Access Compliance Report

Public Rights-of-Way

(Pedestrian Signals)

Intersection ID: N/A	Main Street:	Cross Street: N/A	Location: N/A
ADA ID: 7074395757EA	Signal Type: One Push Button-APS	Overall Compliance: No	Severity Score: BTN 1: N/A BTN 2: N/A No BTN: N/A
Codes/Mitigation Info/Possible Solution		Field Measurements/Component Compliance

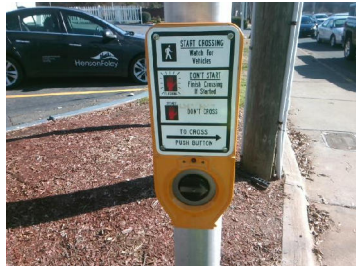
PROW/ADA: TMUTCD 4e.08, R404.3, R404.1, R404.7.3, R209.1, MUTCD 4e.10

Yes	B 1 Clear Xing Direction?	ClearlyMarked	N/A	B 2 Clear Xing Direction?	N/A
	B 1 Crossing Direction	To S		B 2 Crossing Direction	N/A
Yes	B 1 DistanceTo XWalk (in)	0.0	N/A	B 2 DistanceTo XWalk (in)	N/A
No	B 1 DistanceTo Curb (in)	88.0	N/A	B 2 DistanceTo Curb (in)	N/A
Yes	B 1 Diameter (in)	2.0	N/A	B 2 Diameter (in)	N/A

Possible Solutions: Replace Signal Push Button With APS Button on New Post. Remove & Relocate Sign.
